**RE: Main Event, Albuquerque Carpenters Training Center (File: G16-D149)
4040 Pan American Freeway NE 87107
Grading Plan and Drainage Plan, Engineer's Stamp Date 5-27-2015
Engineer's Certification Dated 5-27-16 and 6-6-16**

**RE: Main Event, Albuquerque Carpenters Training Center (File: G16-D149)
4040 Pan American Freeway NE 87107
Interim Grading Plan and Drainage Plan, Engineer's Stamp Date 5-27-2015**

**RE: MAIN EVENT,
PAN AMERICAN FREEWAY AND VASSAR DRIVE
GRADING PLAN AND DRAINAGE PLAN
ENGINEER'S STAMP DATE 3-27-2015 (FILE:G-D149)**

**RE: Main Event, Pan American Freeway and Vassar Drive
Grading Plan and Drainage Plan
Engineer's Stamp Date 3-27-2015 (File: G16-D149)**

Reinforced Concrete Pipe

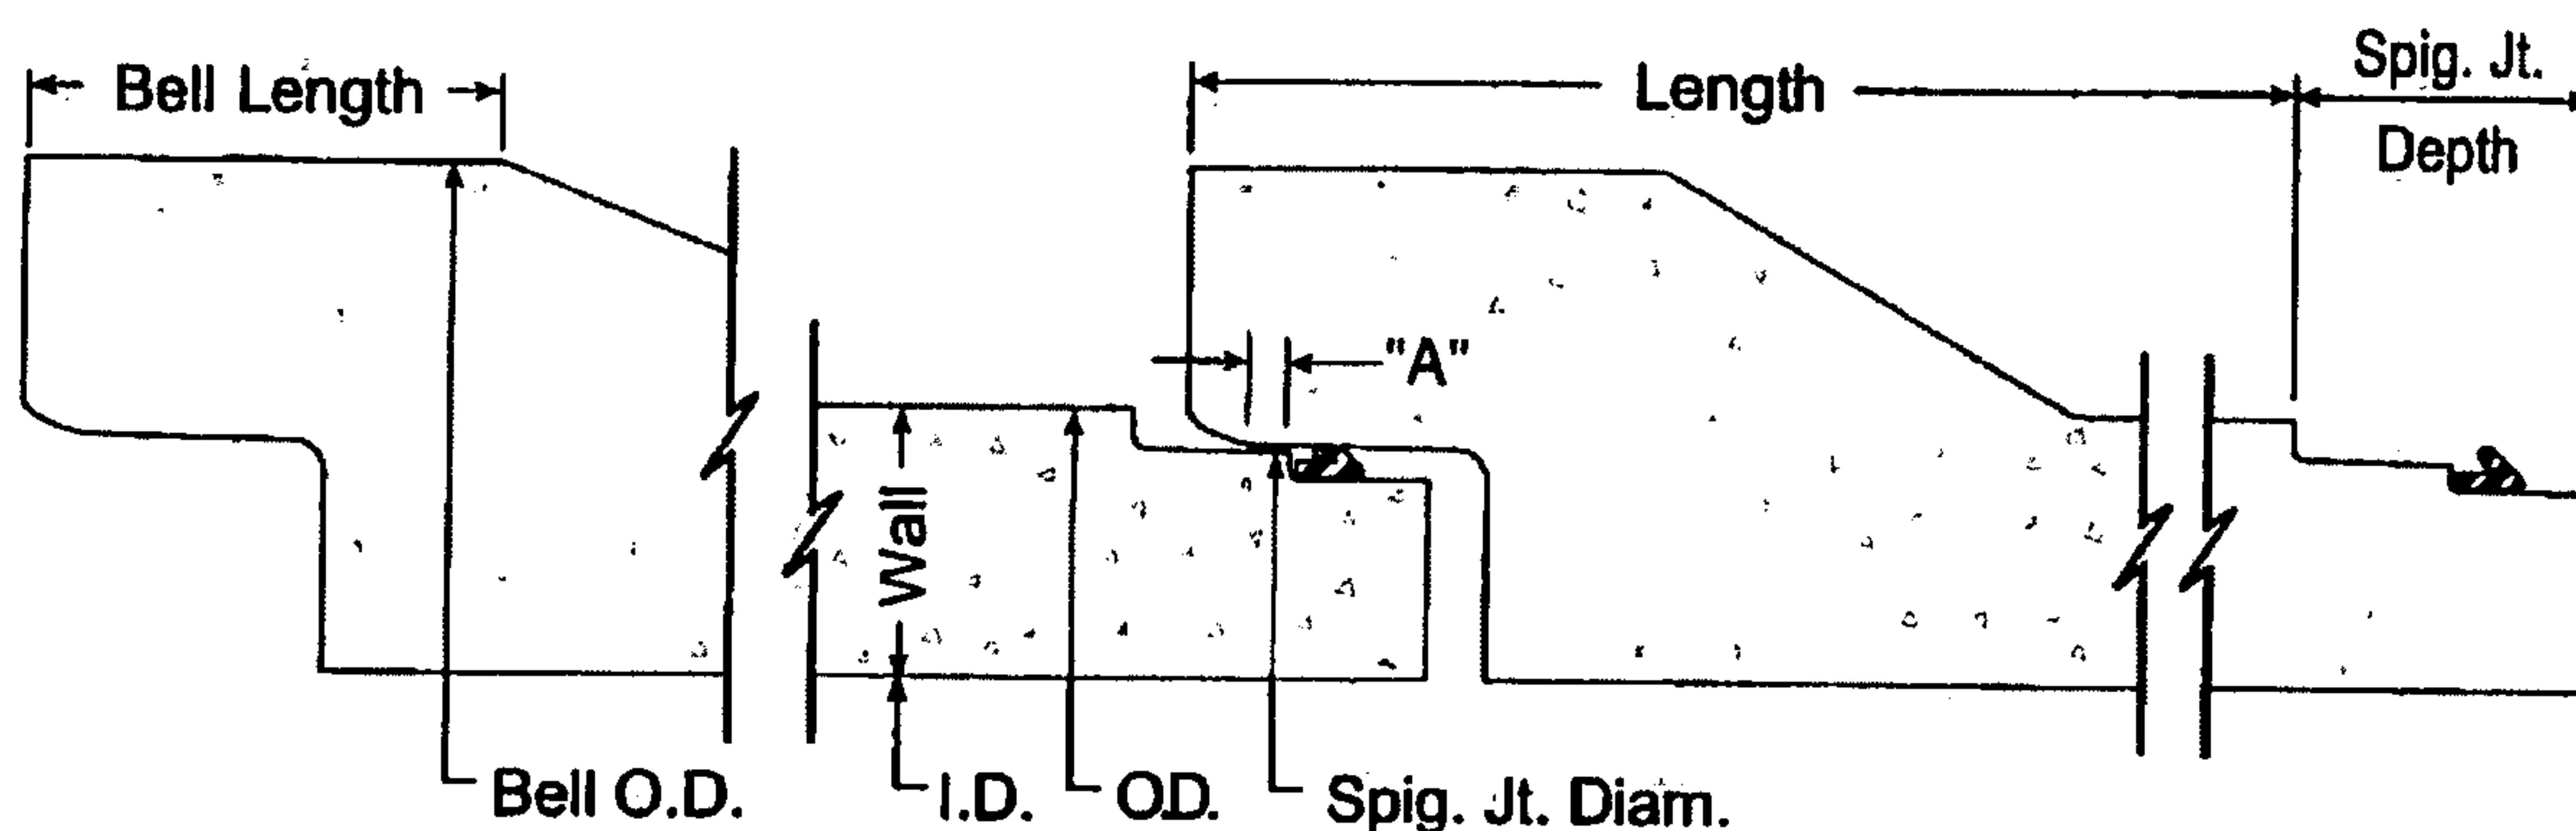
- 2) Calculations by JJK converted the soil bearing load into an equivalent Live Load (eq. LL), and then used this eq. LL to calculate the D-Load (pg 55 of Ch4). I do not believe this methodology is correct as the calculated soil bearing pressure already accounts for both the Dead and Live load. The methodology presented accounts for the Dead Load twice. There were other incorrect assumptions used in the presented methodology:

- 1) Increase the calculated SB pressure under the toe from 1068psf to say 1400 psf to account for no passive pressure.
- 2) Add in Soil weight: $1400\text{psf} + 308\text{ psf} = 1708\text{ psf}$
- 3) For a Class III pipe the Allowable load is $1350\text{ psf} * 1.7 / 1.5 = \underline{1530\text{ psf}}$ -- too Low, N.G.
- 4) For a Class IV pipe The Allowable load is $2000\text{ psf} * 1.7 / 1.5 = \underline{2267\text{ psf}}$. **OK , USE CLASS IV PIPE**
- 5) **USE A CLASS IV PIPE and I Can sign the DRC Set**

It seems that you need to contact the pipe manufacturer and explain that that a retaining wall footing with a Max. Soil Bearing pressure of 1700 psf is bearing on the pipe. He should provide you information as to what the “allowable load”. Allowable loads are different for each diameter, class, and type of Bedding. The type of bedding is generally specified by the geotech. If not, you need to assume a much more conservative type, rather than a Type 1 shown on the calculations.

The calculations show that the bearing pressure of the wall (1401 psf) on the soil between the bottom of the footing and the pipe is well below the allowable bearing pressure identified in the soils report (2500 psf). We have also included a couple of charts showing the D-Load of a 24-inch Class III RCP which ranges from 1350-1600. Since our calculations fall in that range we do not anticipate any problems with this pipe going under the retaining wall as we currently have it designed.

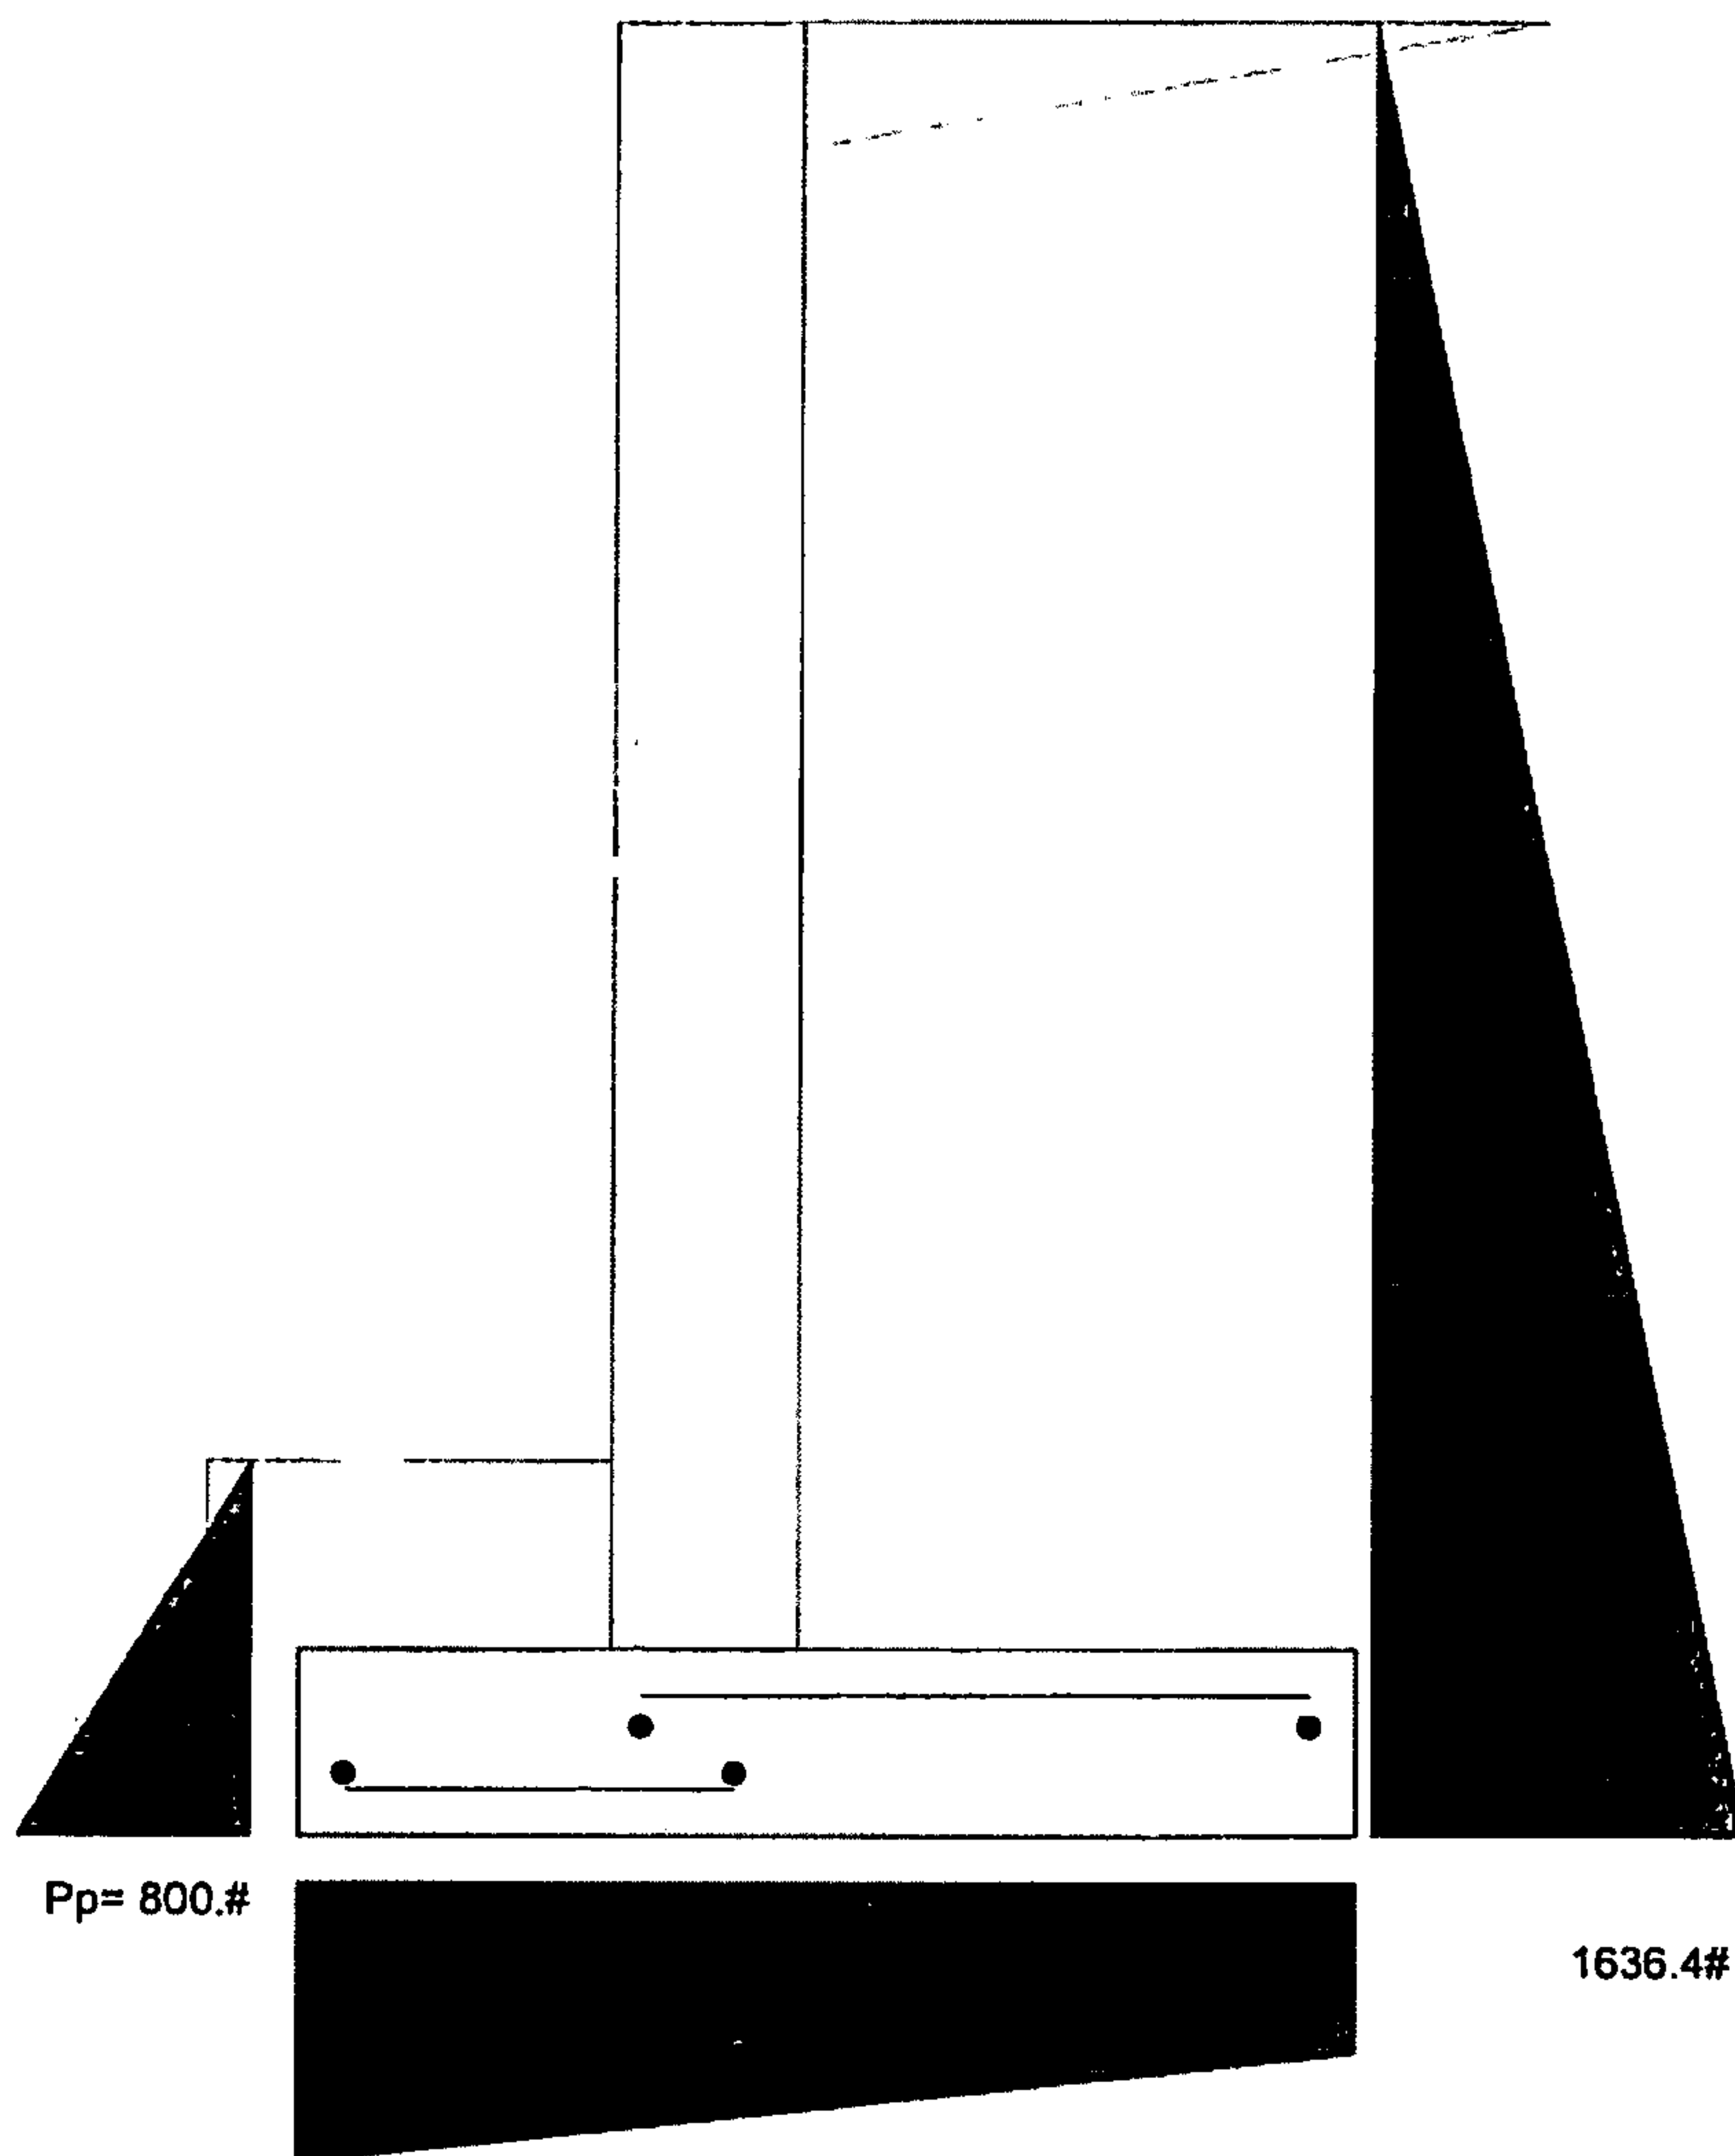
$$2.88' \times 107 \text{pcf} / \text{ft} = 308.16 \text{ psf (ADDED) - Soil over pipe}$$

(Net) TOTAL LOAD 7870# Concentrated LOAD MAX
